CHANGE ORDER

No. 9

TITLE: C3M - Option 1 and 2 Feeder Cable Replacement
 PROJECT/CODE: SGR397 - TPSS Component Replacement
 TO: C3M
 ATTN: Salvador Benitez

SUBJECT: Option 1 & 2 Feeder Cable Replacement

TRACTION POWER SYSTEM
900 EAST SUBSTATION
 UNDERGROUND RACEWAY AND CABLE PLANS
 SUBSTATION TPS E2
 SHEET 1 OF 2

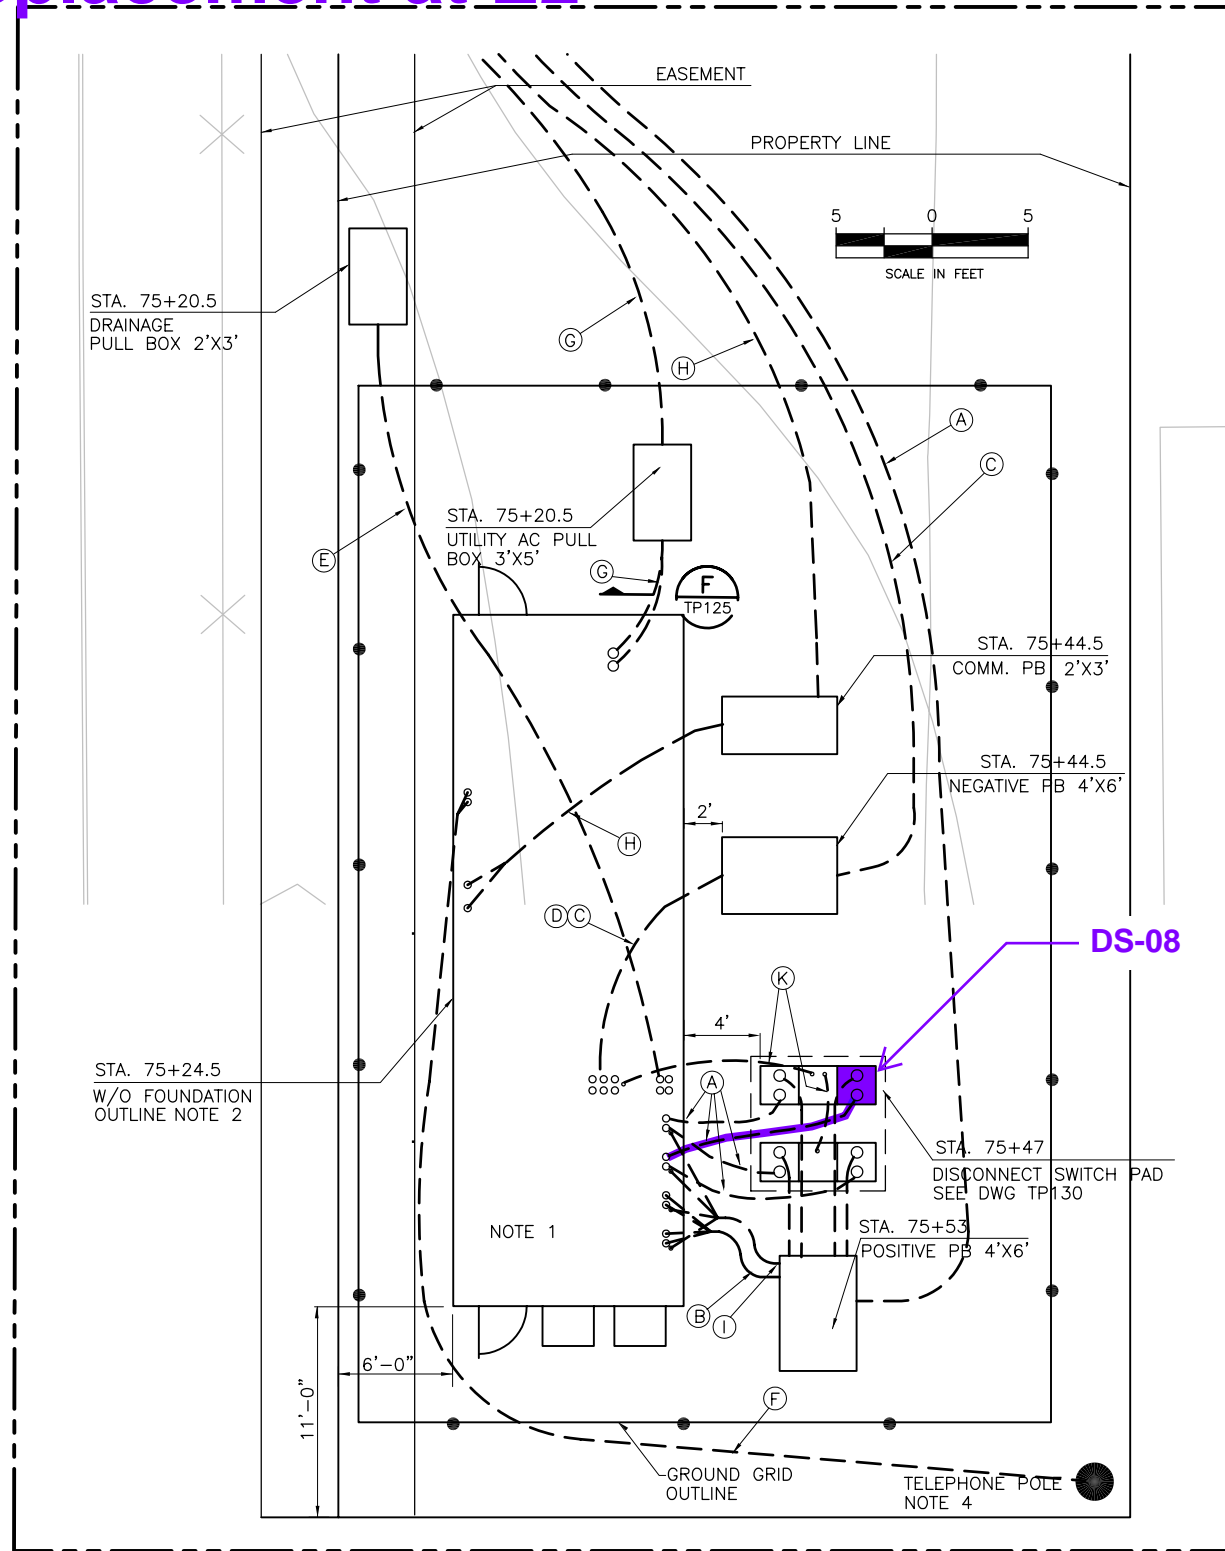
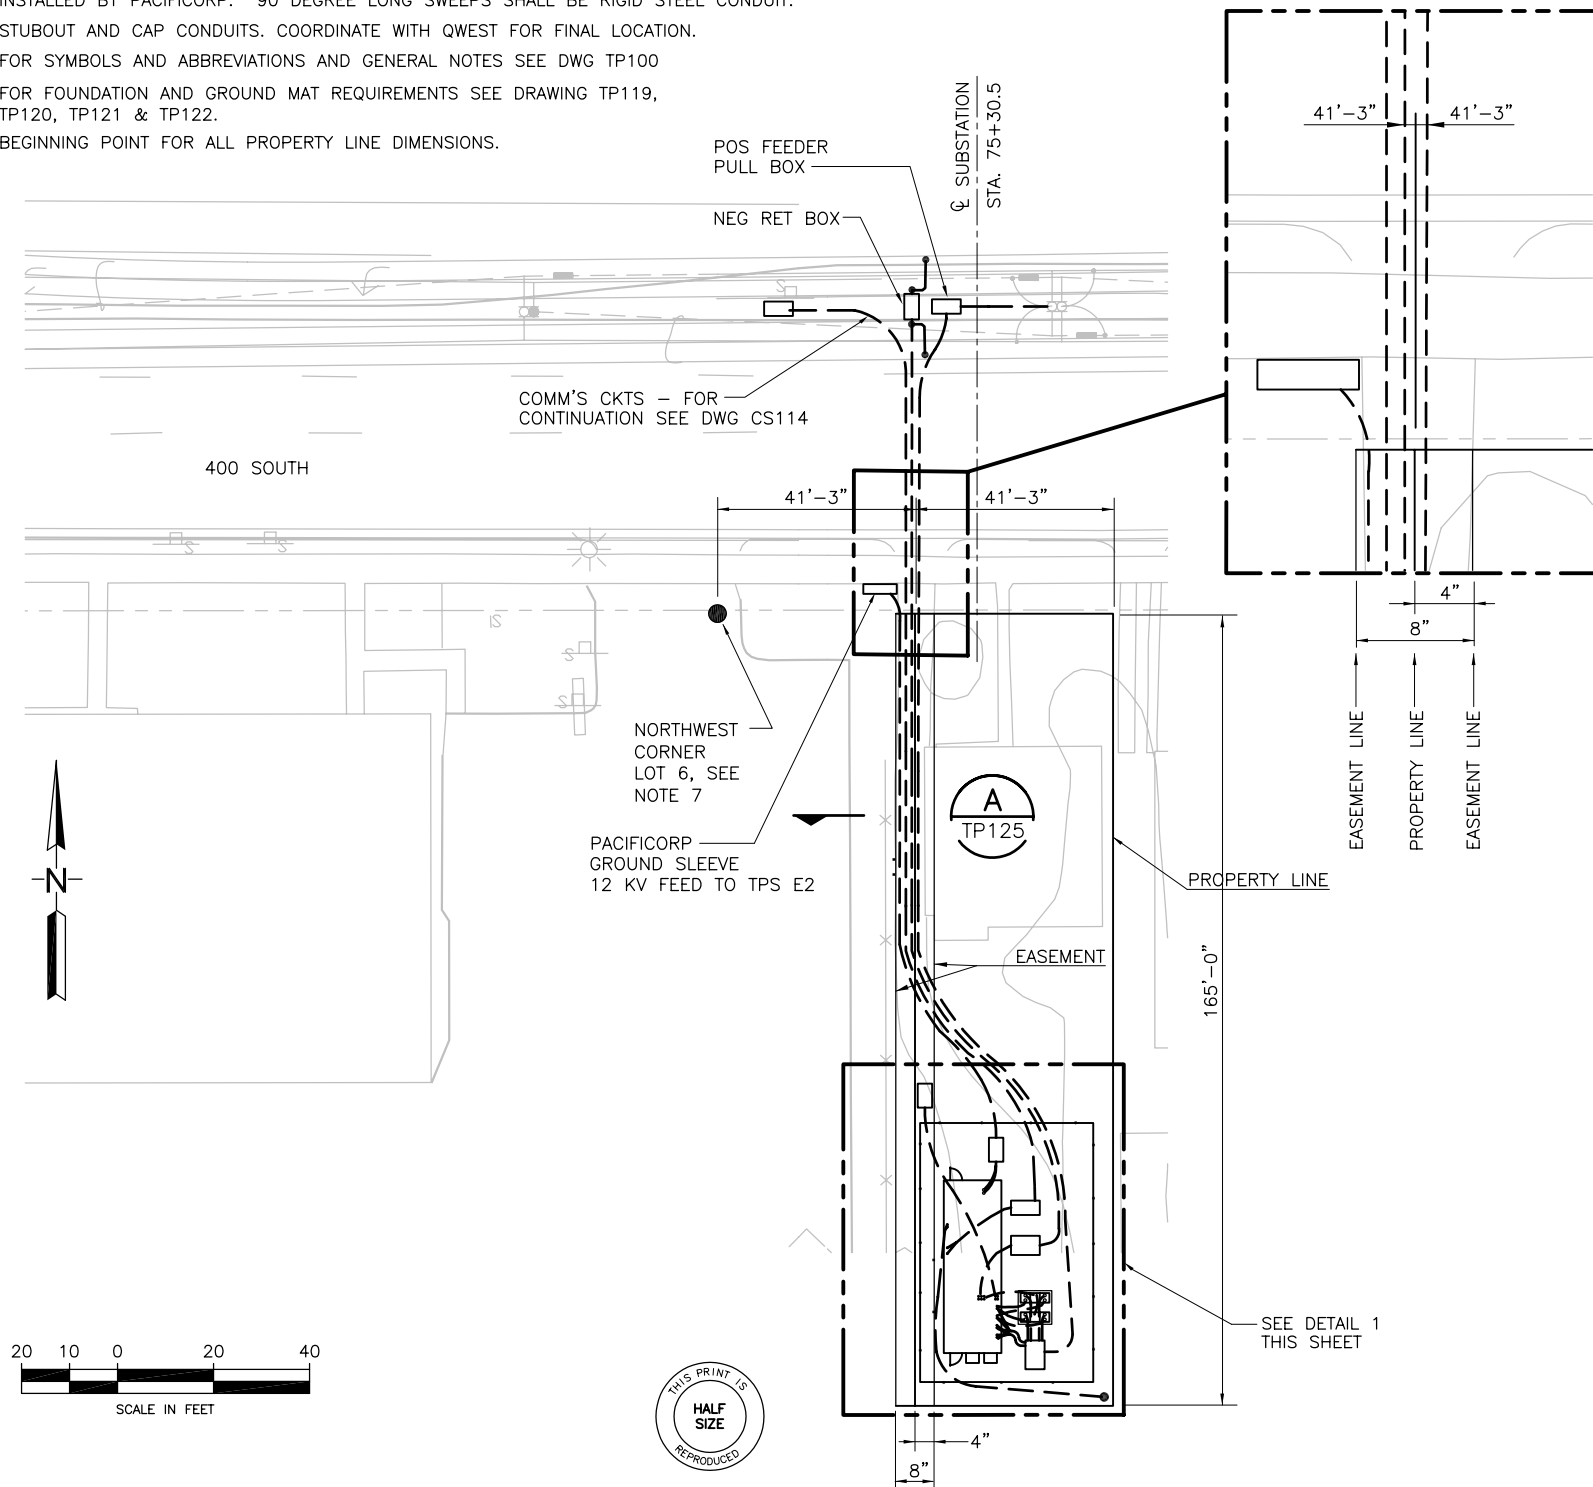
The POS feeder cables at E2 900E were megger testing from the feeder breakers to the OCS. One cable from Feeder Breaker 2 to DS-16 tested at 2.6 MOhms which is below the limit of 5 MOhms set by the UTA and is recommended for replacement. The cable was marked with orange tape to identify it (see photos). The two adjacent cables that share a conduit with this cable will also need to be replaced to facilitate installation. Other cables from DS-11 to OCS and DS-16 to OCS tested below the max of 2.2 GOhms but above the lower limit of 5 MOhms (see megger sheets). The NEG cables were not tested at this location as they are welded to the embedded rail with no impedance bonds to disconnect and test from.

Option 2D. Negative Return Cable Replacement at SRS11

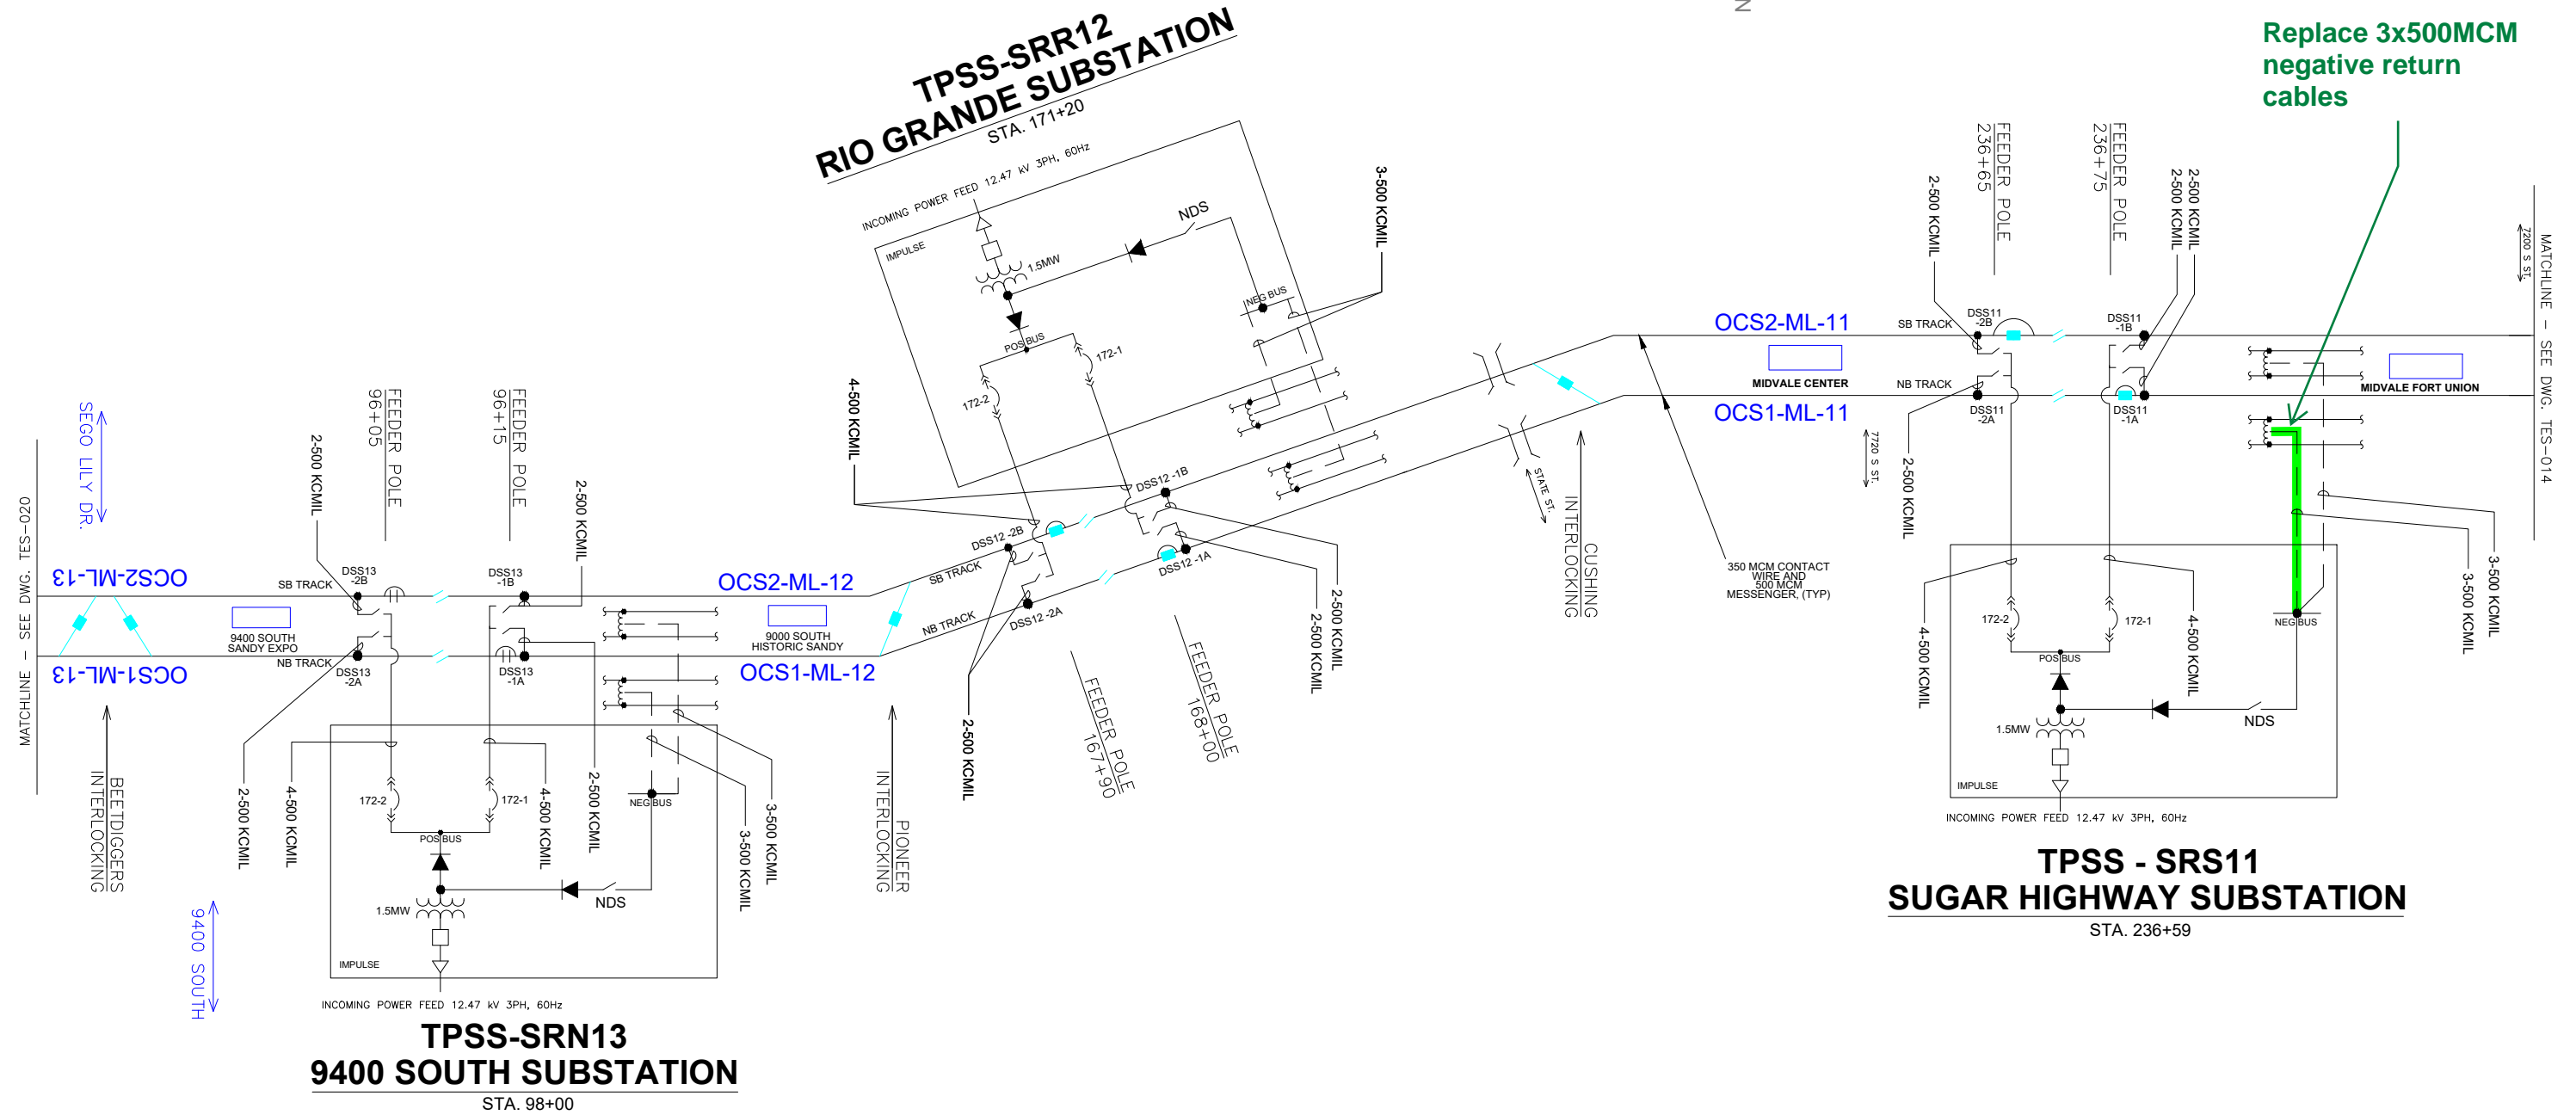
- Option 1E - E2 900 E will only replace a set of 3-500s from DC Feeder Breaker F1 to the pad mounted disconnect switch DS-16.
- Option 2D - SRS11 Sugar Highway will only replace a set of 6-500s from the negative cubicle to the termination on the northbound tracks.

TRACTION POWER AND SIGNALING
SUGAR HIGHWAY SUBSTATION
UNDERGROUND RACEWAY AND CABLE PLANS
SUBSTATION SRS11
SHEET 1 OF 3

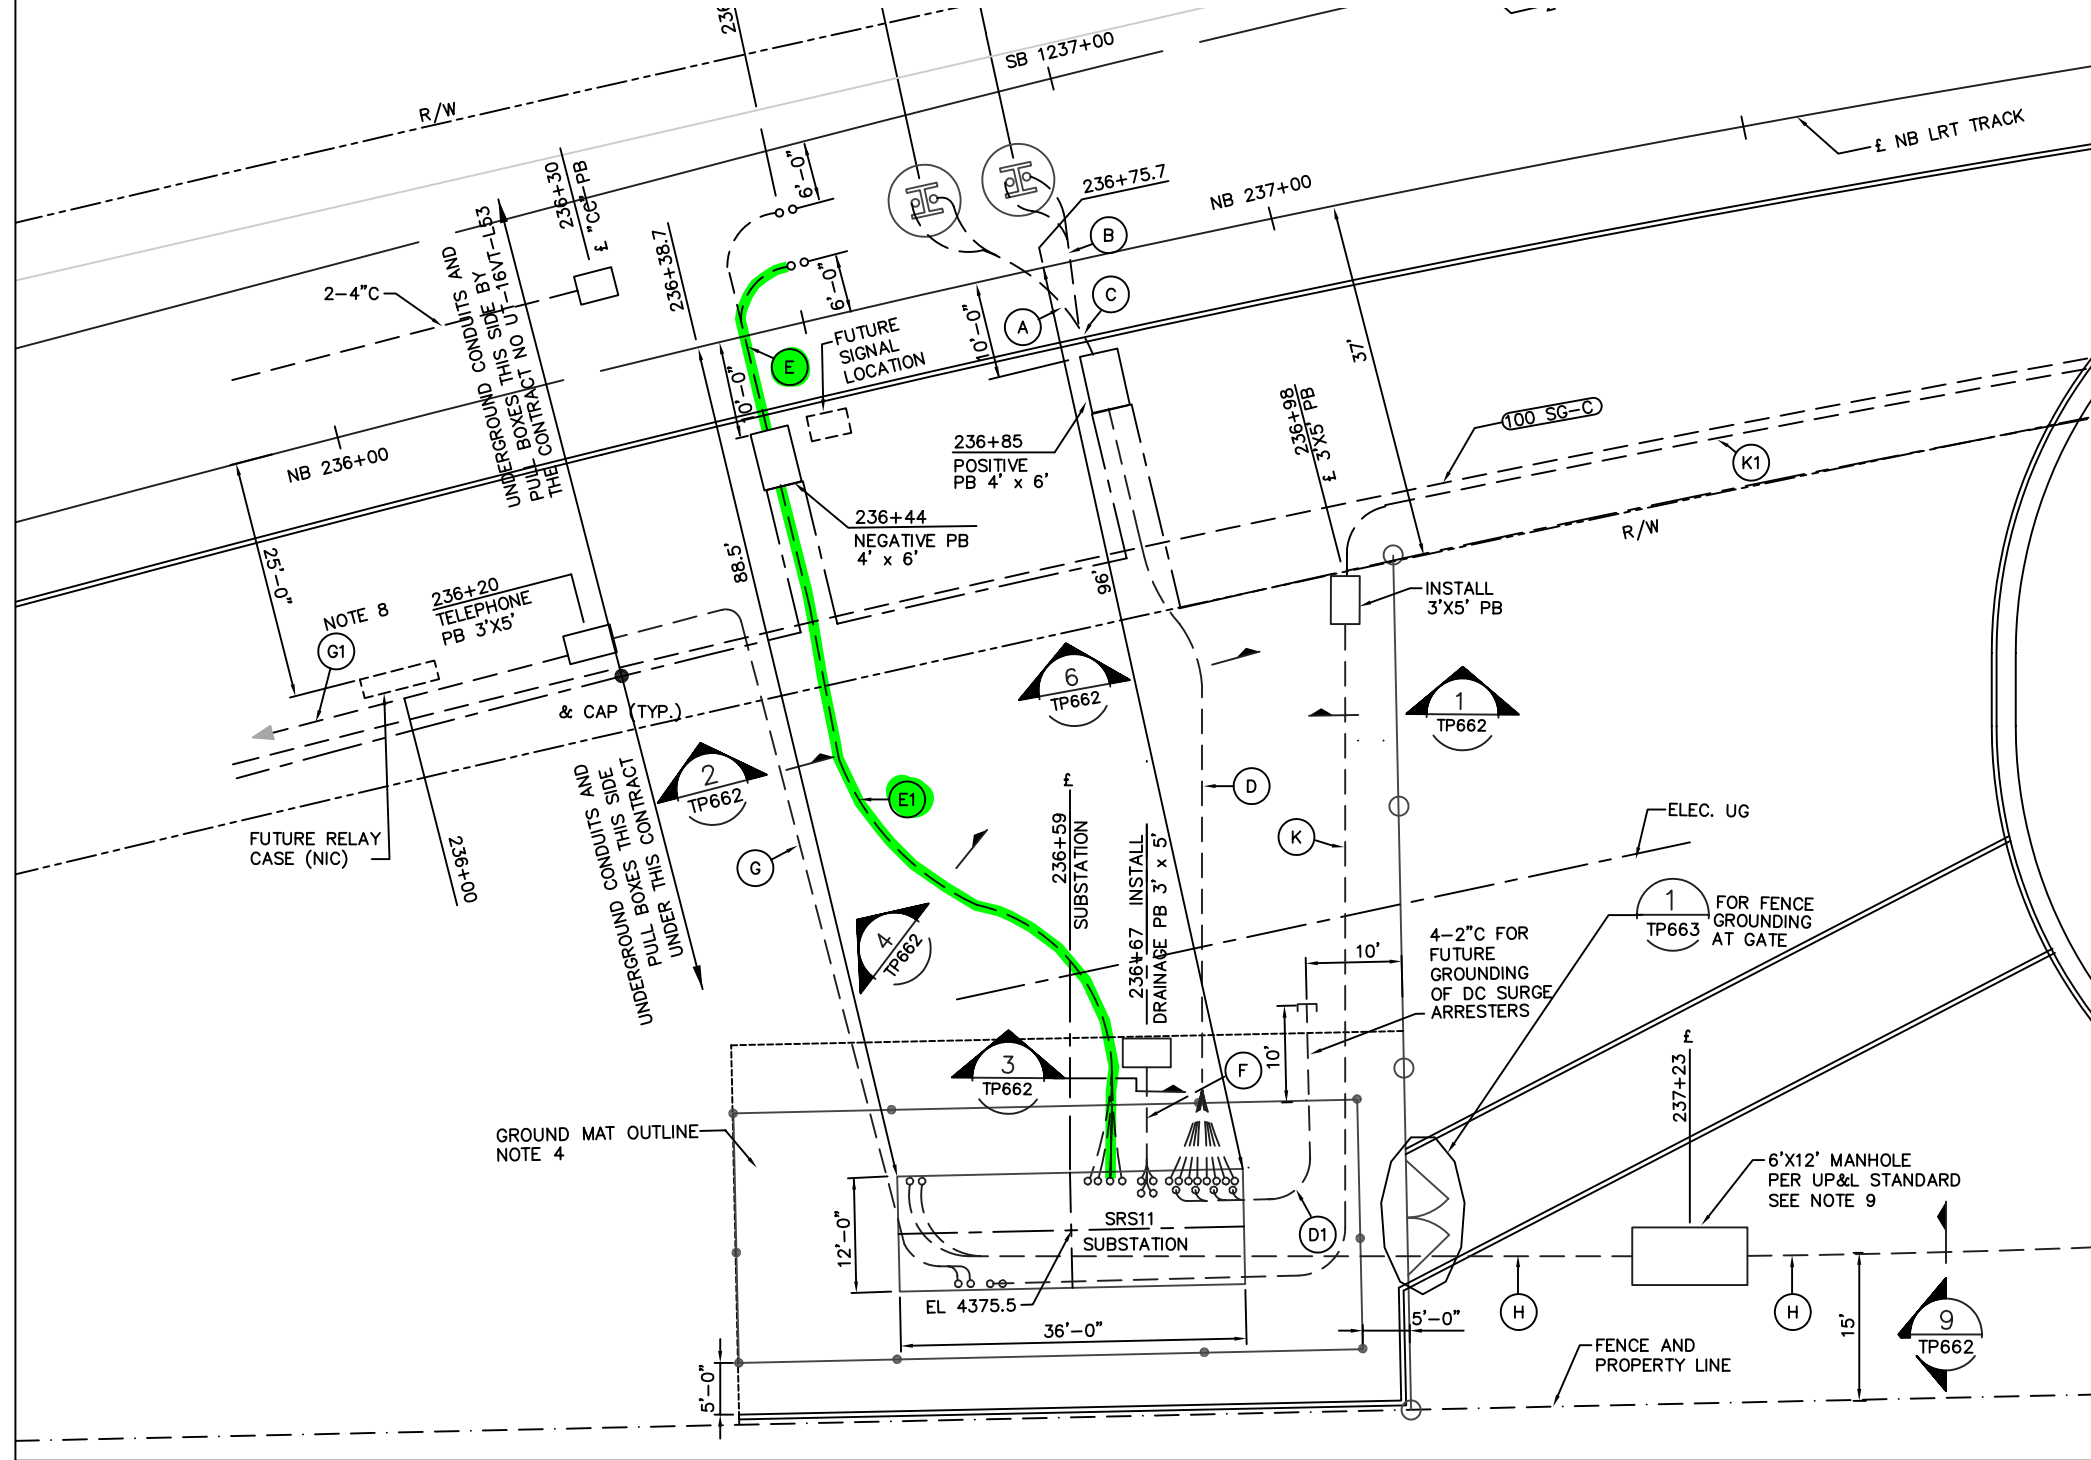
The NEG feeder cables at SRS11 Sugar Hwy were megger tested from the cubicle to the impedance bond, one cable gave a low reading of only 2.6MOhms. Per the UTA approved testing procedure any cable testing less than 5MOhms is to be considered for replacement. This cable shares a conduit with two other cables and C3M recommends they also be replaced to ease replacement of the low testing cable. The cable which tested low is number 2 counting from front to back from inside the TPSS. The cable was also wrapped in orange tape to help identify it in the future.

Additionally, the insulation of the negative jumper cable at the impedance bonds was found to be damaged. The cable connects the northbound and southbound impedance bonds together; the damage is near the southbound impedance bond.
